SIGN APPLICATION-TOWN OF ESSEX

Address of Sign Location: 15 ESSEX WAY MAP 092 PARCEL 001 LOT 000
Business Name for Sign: BIBEUS ACE

EXTERIOR ELEVATIONS - SIGNS CALCULATED BY BLOCK AREA

**BIBENS ACE HARDWARE
 LANG FARM CENTER**

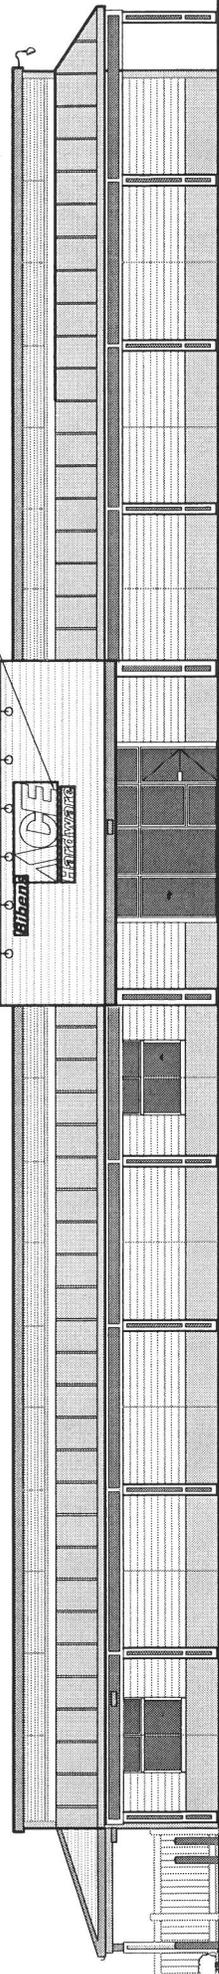
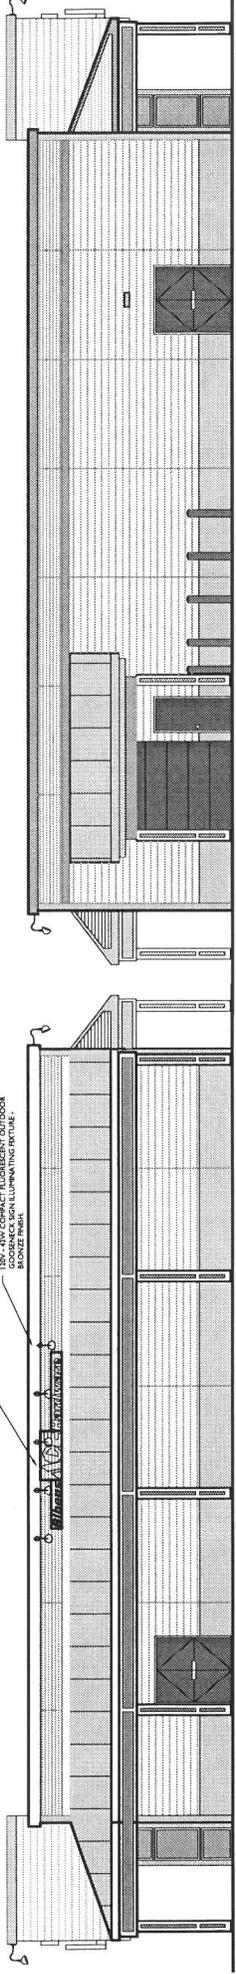
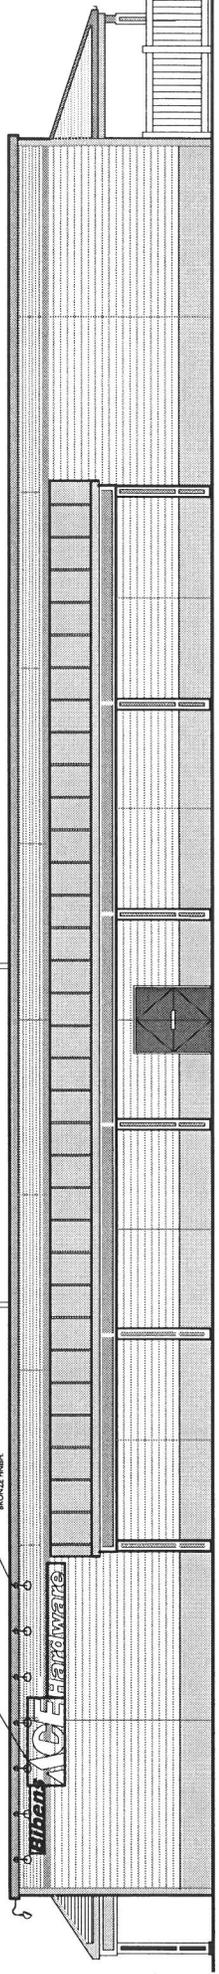
The applicant proposes signs for the main entrance, the south and east sides of the building as shown on the attached "Exterior Elevation – Signs and Sign Lighting" plan. The sign area does not exceed the maximum sign area of five percent allowed. The maximum the main façade sign has sign characters of four feet in height, the maximum allowed. The signs and illuminated by compact florescent gooseneck sign lights that would light the signs from the top down.

The applicant proposes signs for the main entrance, the south and east sides of the building as shown on the attached "Exterior Elevation – Signs and Sign Lighting" plan. The sign area does not exceed the maximum sign area of five percent allowed. The maximum the main façade sign has sign characters of four feet in height, the maximum allowed. The signs and illuminated by compact florescent gooseneck sign lights that would light the signs from the top down.

On this 11 day of FEBRUARY, 2008, your application was:
P.C. granted approval on 9/20/07 approved denied.
see attachment. TO be constructed pursuant to PC Approval.
